Report on Key Objections to the Proposed Gardeners' Building on the Mound at Highgate Cemetery

Planning Application Reference: 2024/5407/P

Observations on Submitted Proposals

OUTLINE OF BUILDING AS SEEN FROM THE END OF THE PATH ON THE MOUND WITH PERSON AT THE RIGHT SCALE

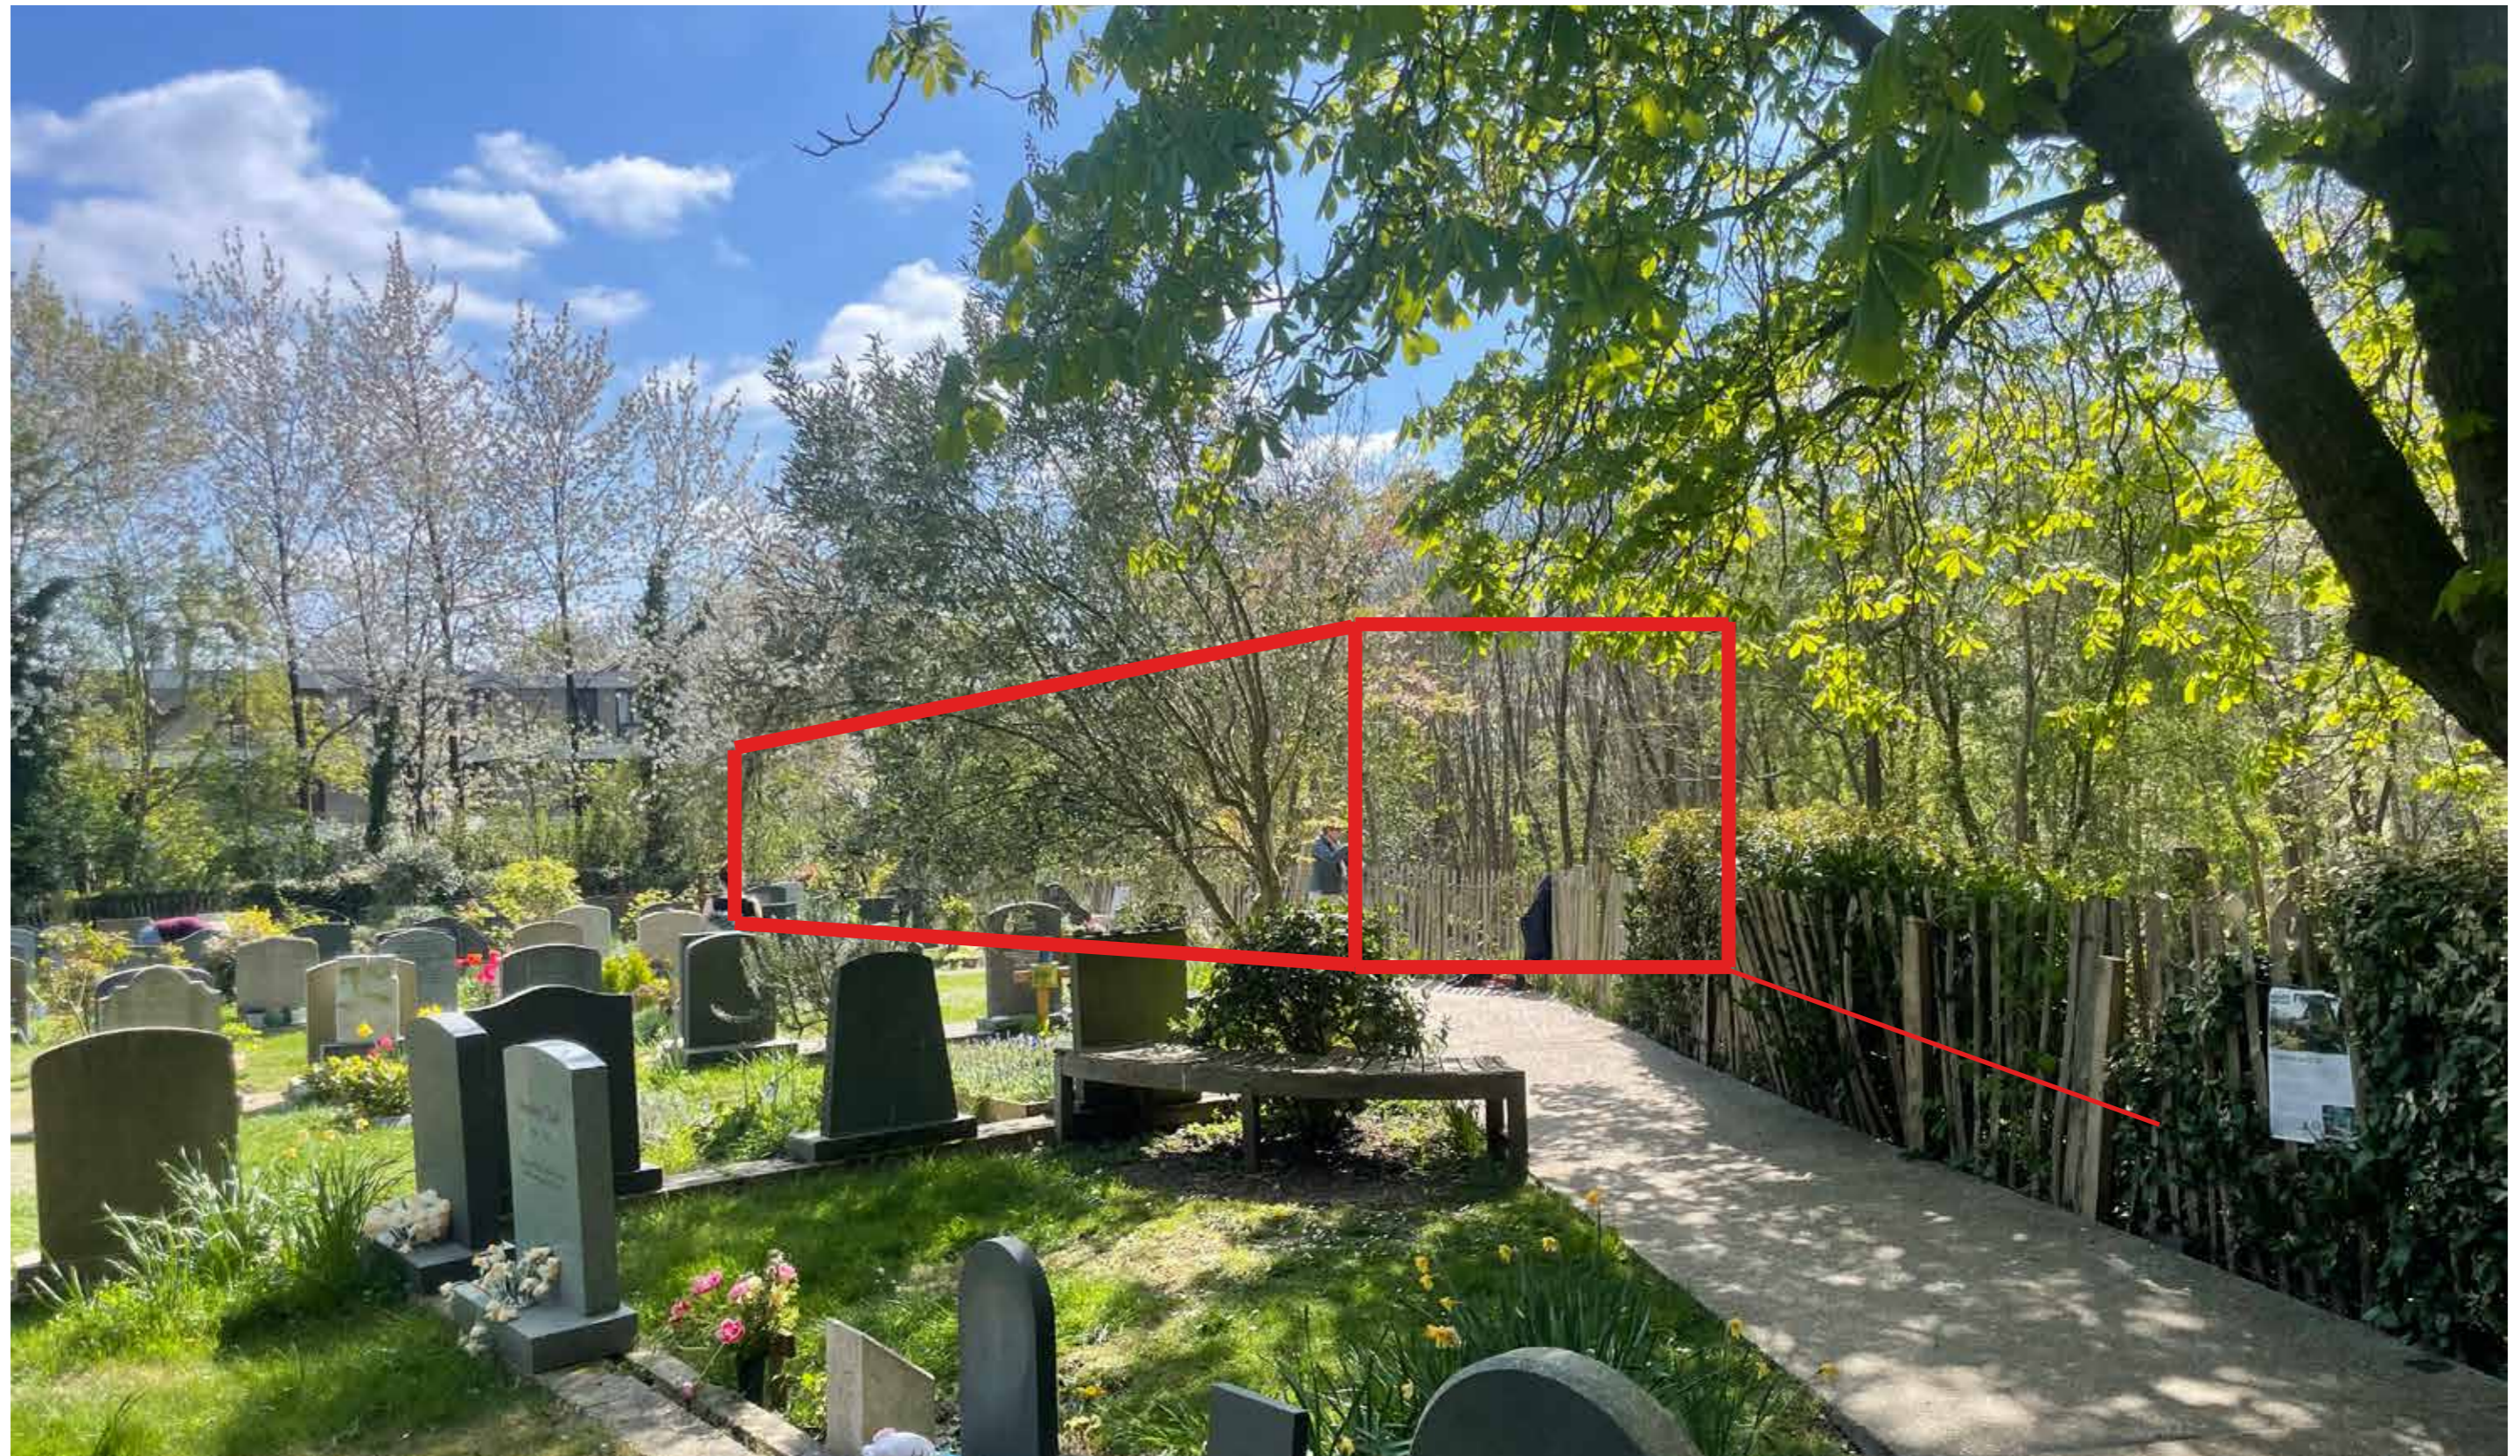
PUBLISHED PHOTOMONTAGE IS MORE OF AN IMPRESSION THAN AN ACCURATE REPRESENTATION OF THE SCALE OF THE PROPOSED GARDEN BUILDING

OUTLINE OF BUILDING AS SEEN FROM NEAR THE RAMP ACCESS TO THE MOUND
